Re: Frame Access Grabhandle (Location)
NHTSA Recall No.: 03V-234
Kenworth Recall No.: 03KWS

FEDERAL RECALL CAMPAIGN 03KW5

T600, T800, T2000, and W900 MODELS BUILT NOVEMBER 22, 2002 THROUGH APRIL 30, 2003 CONTAINING FRAME ACCESS GRAB HANDLES WITH VERTICAL TAILPIPES.

Figure 1

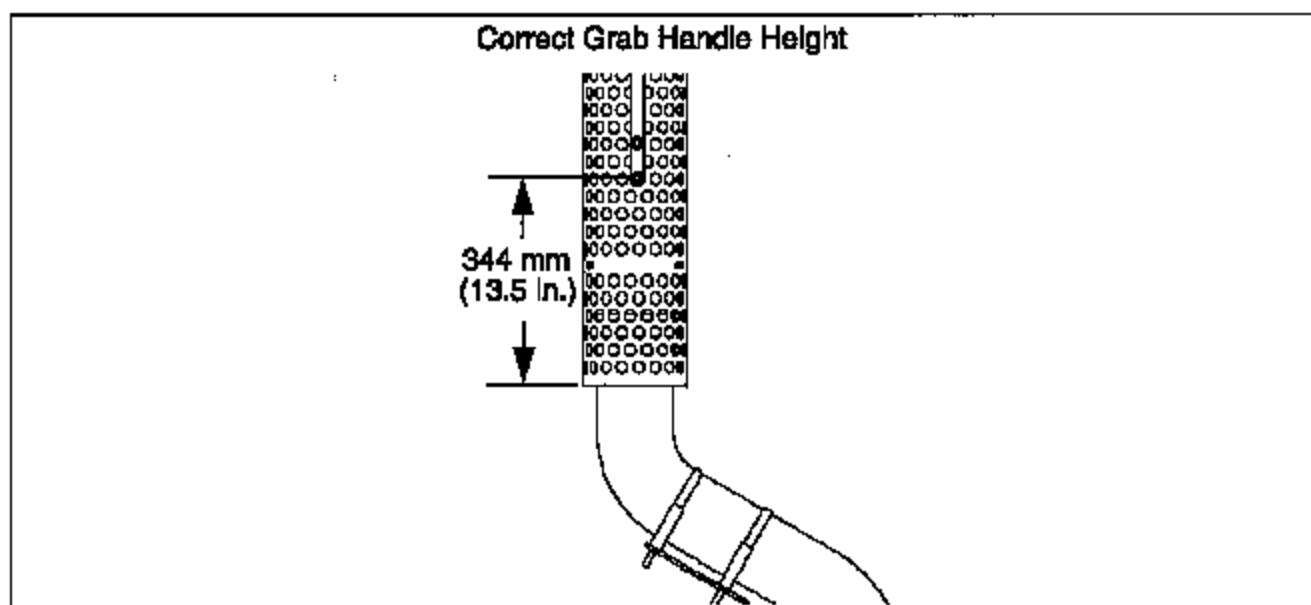
Kenworth Engineering became aware that the grab handle on certain engine/muffler/tailpipe combinations were being mounted too high to be effective. After further investigation, Engineering determined the location failed to meet the recommended guidelines for safe ingress/egress. The location may limit the ability to maintain 3-points of contact at all times per industry standards. This defect may cause a person to slip and fall when trying to hold the grab handle.

Kenworth has initiated a recall to inspect and, if necessary, relocate the grab handle to the proper height. See attached sketch for "Correct Grab Handle Height" on page 2.

Figure 1

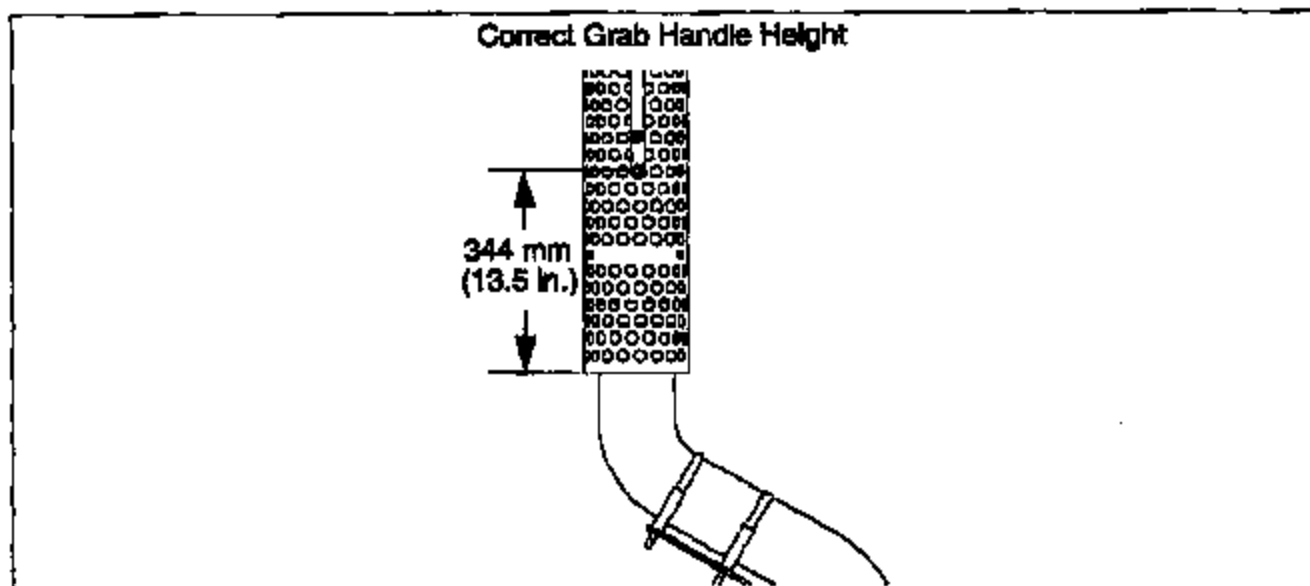
Kenworth Engineering became aware that the grab handle on certain engine/muffler/tailpipe combinations were being mounted too high to be effective. After further investigation, Engineering determined the location failed to meet the recommended guidelines for safe ingress/egress. The location may limit the ability to maintain 3-points of contact at all times per industry standards. This defect may cause a person to slip and fall when trying to hold the grab handle.

Kenworth has initiated a recall to inspect and, if necessary, relocate the grab handle to the proper height. See attached sketch for "Correct Grab Handle Height" on page 2.
